CITY OF YPSILANTI
Agenda
Historic District Commission
Tuesday, October 24, 2017 - 7:00 p.m.
City Hall Council Chambers, 1 S. Huron
Ypsilanti, MI 48197

HDC Work Permit Staff Review

Property address: 39 E Michigan

Proposed work: exterior image upgrade including lights, signage and awnings.

Type
E2

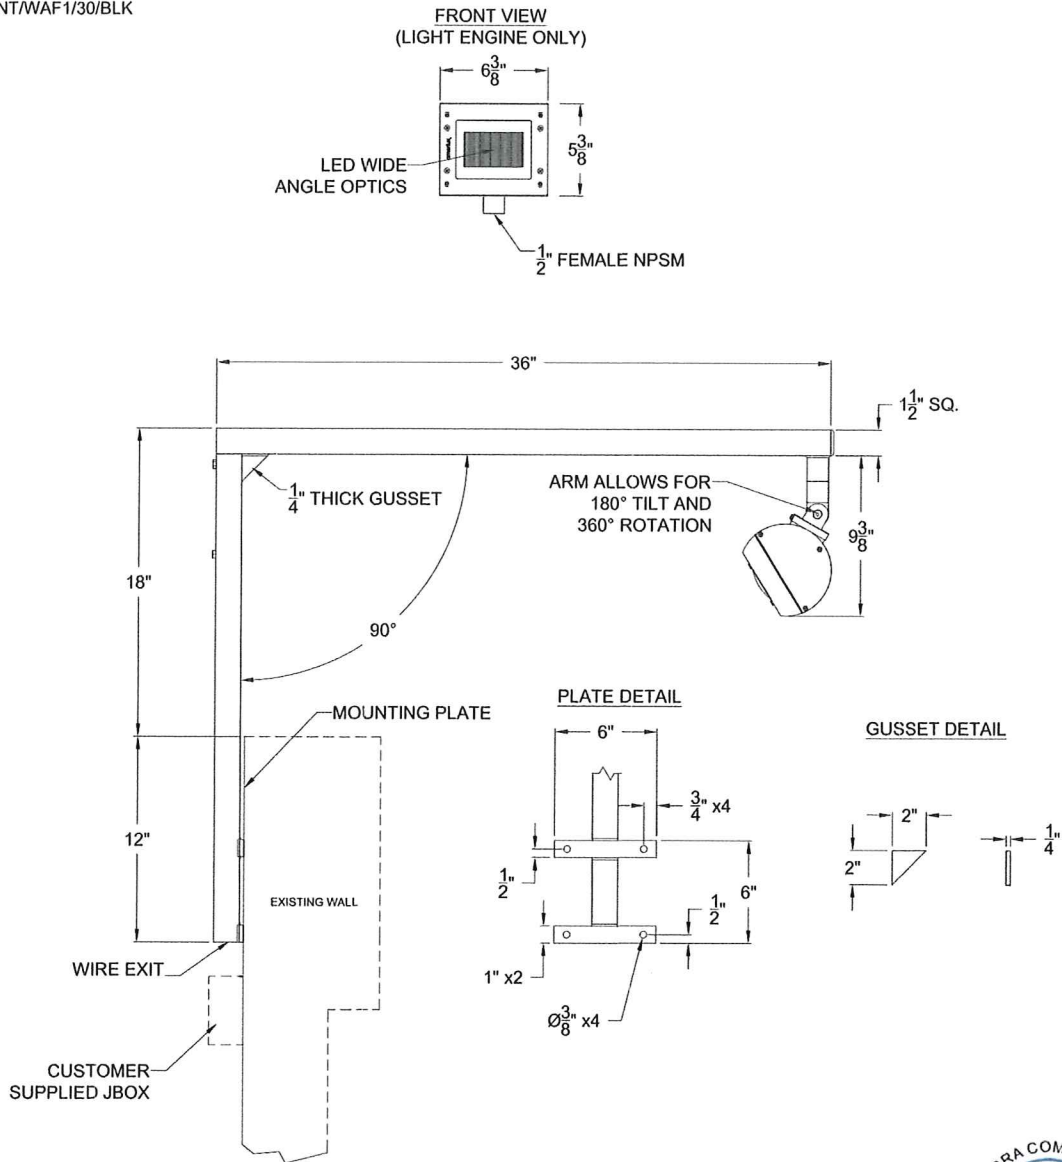
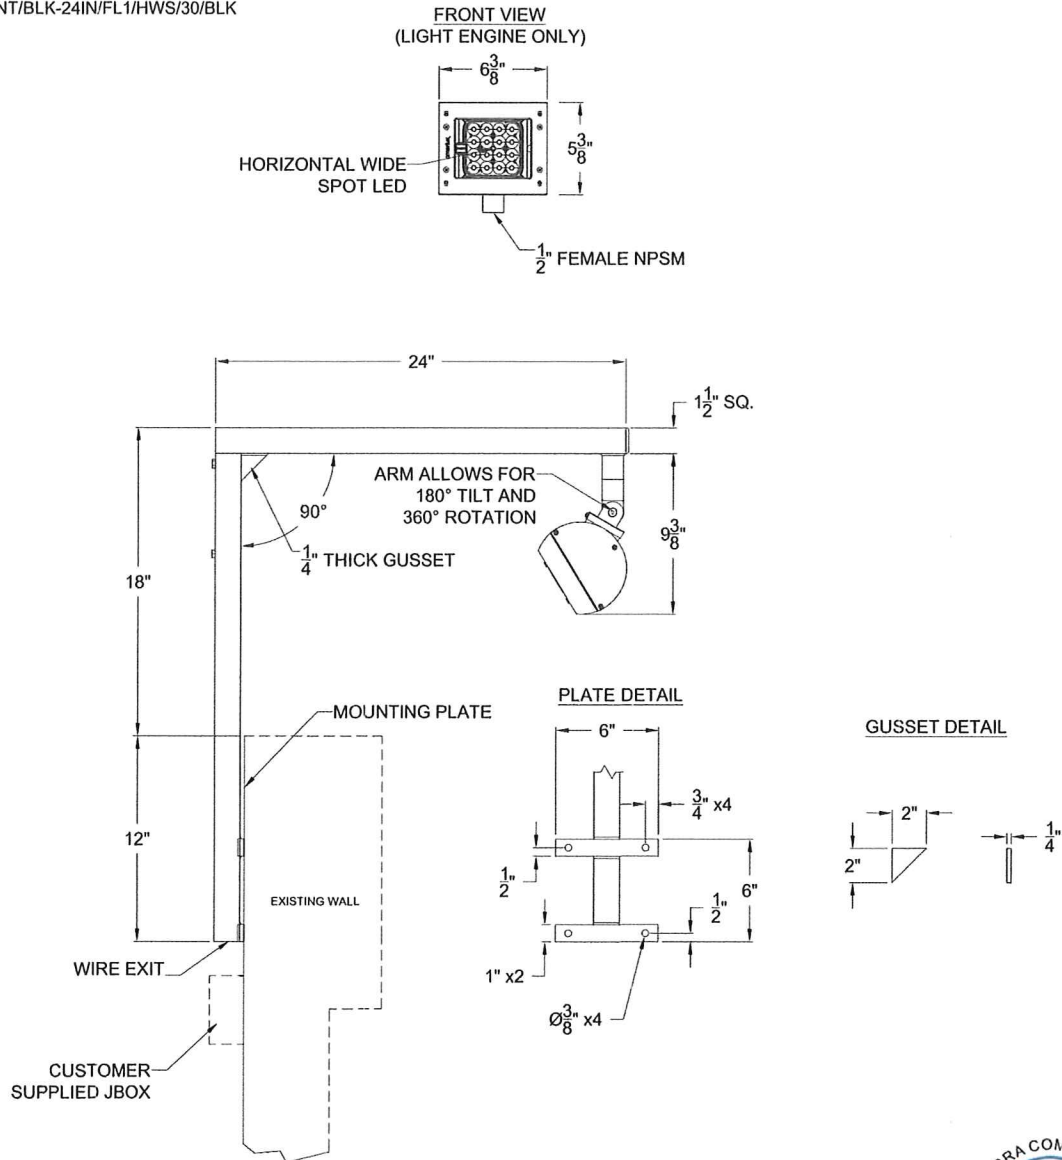
3. The existing striped awnings will be replaced with solid red awnings.
4. New lighting will be installed on the structure. HDC to verify if lighting meets current lighting HDC lighting standards. These flood lights do not appear to be dark sky complaint. Staff has advised the applicant that the E1 and E2 light fixtures will need shields in order to comply.

existing striped awnings with solid red awnings, the installation of new LED floodlights with glare shields and wall pack LED lights under the new awnings. Signage will be modified according to the site plans dated May 31, 2017. Work to also include the pressure washing, patching and repairing as needed.

EXISTING DRIVE-THRU ELEVATION

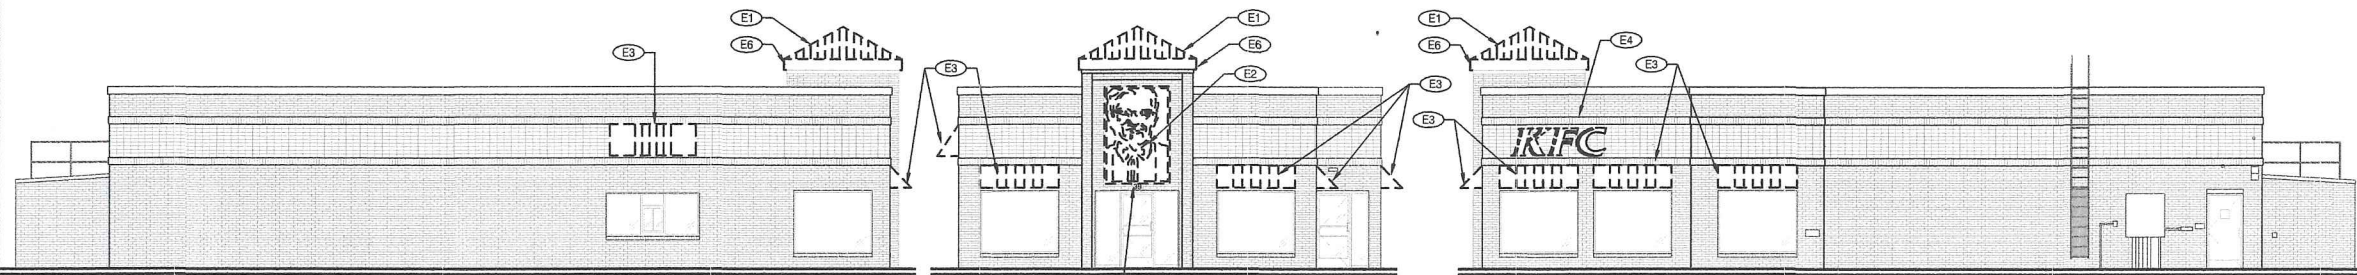
1. This item was tabled from the last meeting due to no owner permission, staff has since received the necessary paperwork.
2. The plans indicates that the striped pyramid shroud and the tower metal wall coping cap at the front will be removed.

Move to approve the work for the 39 E Michigan to include the removal of the striped pyramid shroud and the tower metal wall coping cap at the front. Work to also include the replacement of the

SITE PLAN PREVIOUSLY SUBMITTED

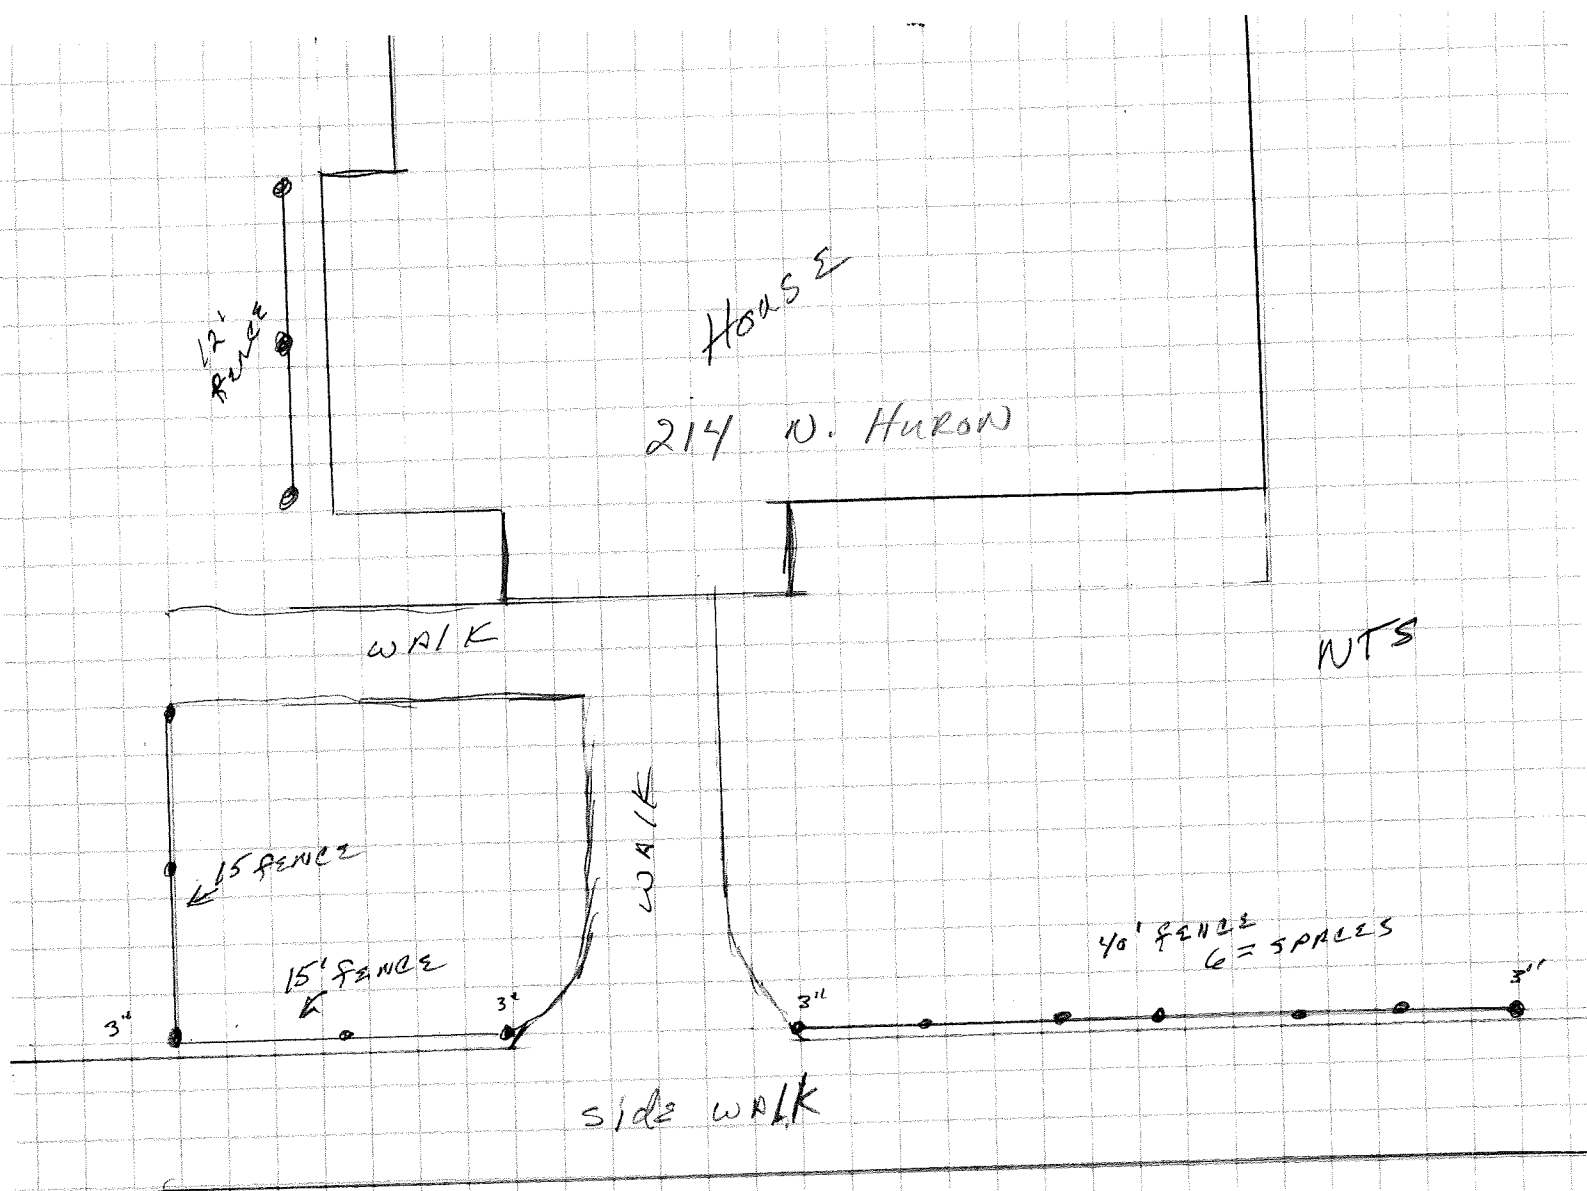
1. Applicant has had this historic fence restored and is now looking to install the fencing in the front yard at this address. A site plans is attached.
2. Staff has requested a photo of a finished section from the applicant and has included older photos of the fencing from when the applicant came in as a study item for this previously.
3. The applicant is planning on painting the fencing in a Rustoleum stain finish hunter green.
4. A building department permit will be required for this work, applicant to obtain permit prior to commencing work.
5. Fencing is subject to the zoning ordinance.

Move to approve the work at 214 N Huron for the installation of the historic cast iron fence in the front yard as depicted in the site plan submitted with the application dated October 11, 2017. The fencing will be painted in Rustoleum stain finish in hunter green.
